**PREVOST**

WARRANTY BULLETIN

WB14-32

DATE :	SEPTEMBER 2014	SECTION: 06- Electrical
EXPIRATION:	SEPTEMBER 2016	
SUBJECT :	MASTER RELAY CORROSION

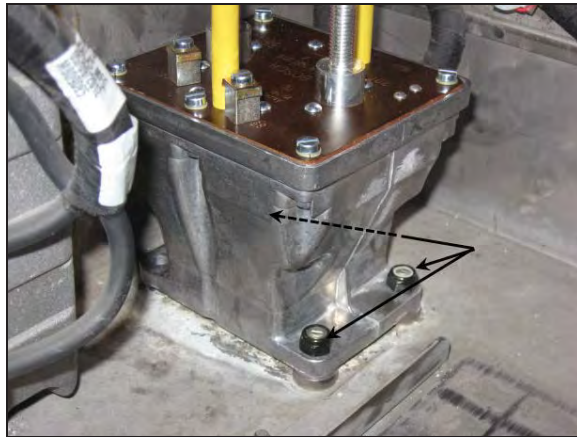
12. With the help of an assistant, install the three (3) new 30mm bolts from under the vehicle and slide the six (6) stainless flat washers over the bolts threads in the battery box.

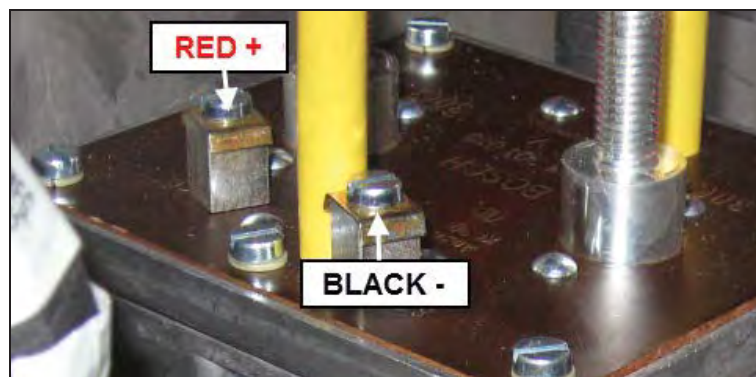
13. Remove the cover from the new relay and install the relay over the stainless washers. Hand tight the three (3) provided hex nuts.

14. Tighten the three (3) hex nuts to 16 ft-lb (22 Nm).
